# Device Errata

## NL-SWDK2

NimbeLink Corp

Updated: September 2021

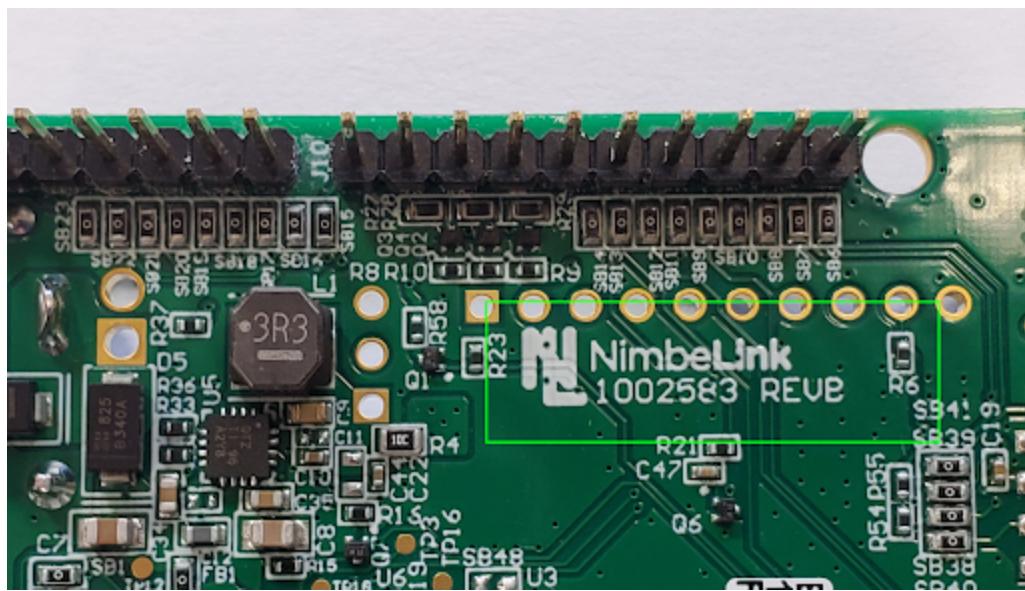
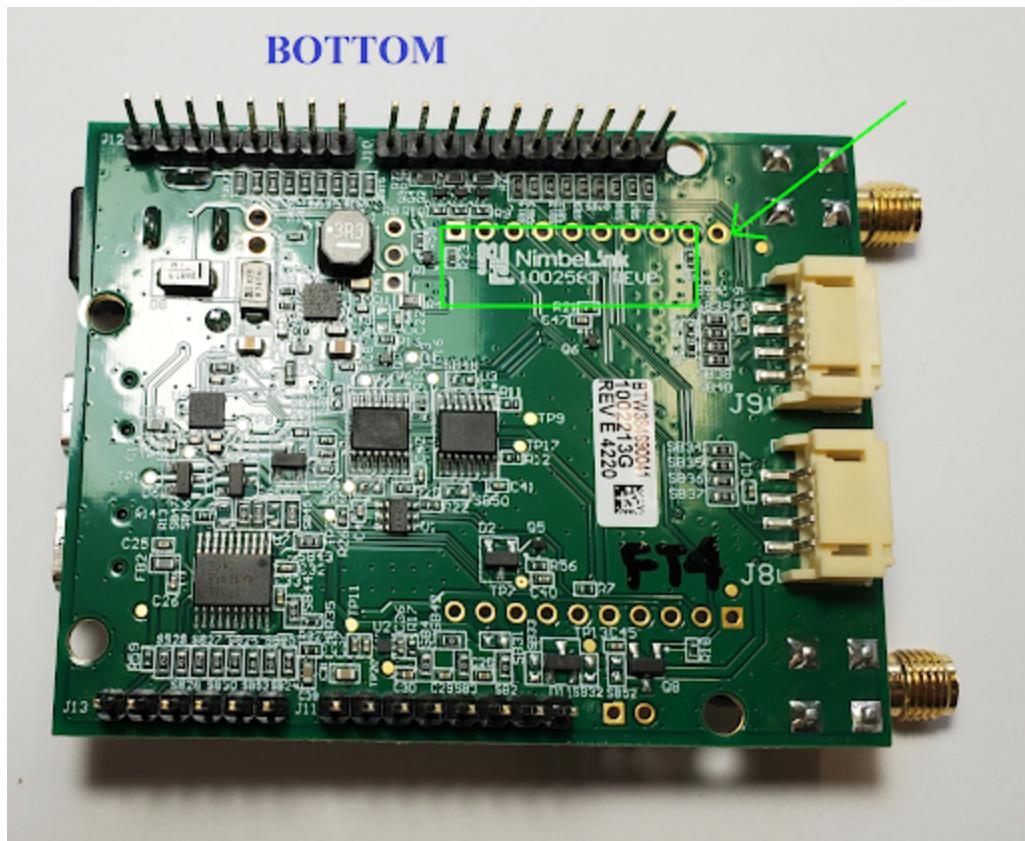
Affected devices can be identified by checking their part number on the devices PCB Silkscreen. All devices with part numbers 1002583 are affected. Check the bottom of the PCB to locate your assembly and revision number.

The assembly number is shown in the image above, inside of the green box.

## 4. Details of Error

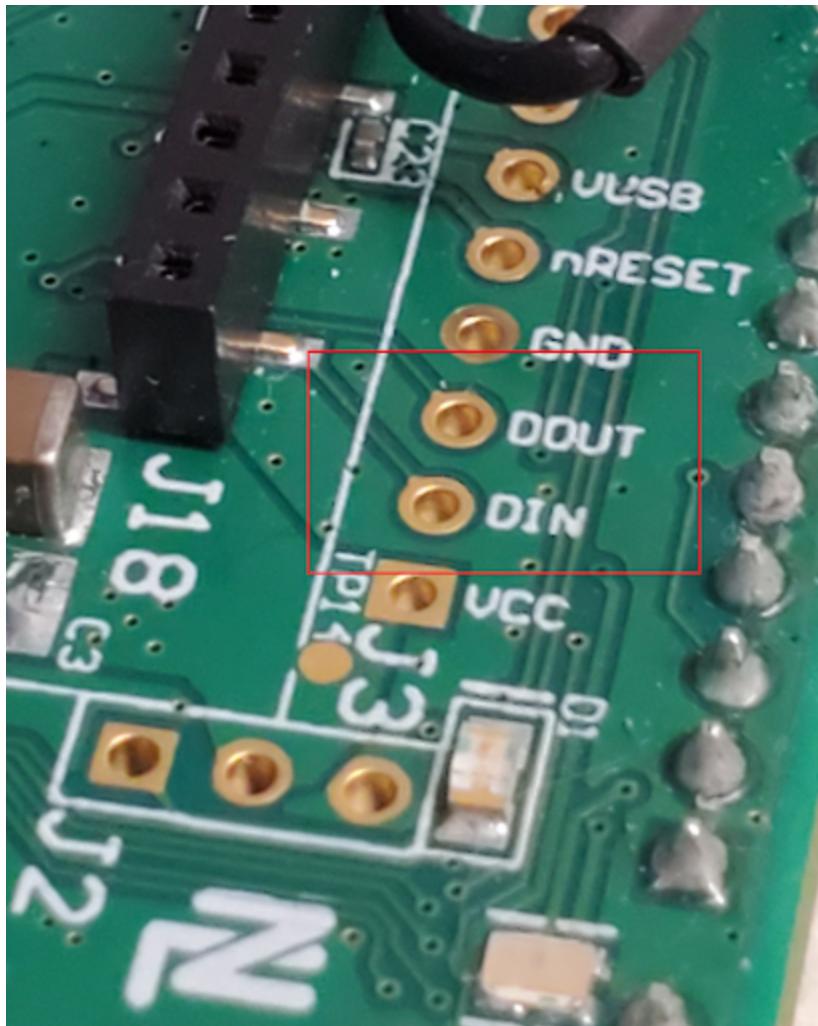
The silkscreen labels for DOUT and DIN are swapped on the J3 connector. DOUT should be DIN and vice versa.

Please refer to the SWDK2 schematic for the correct pinout of the J3 header
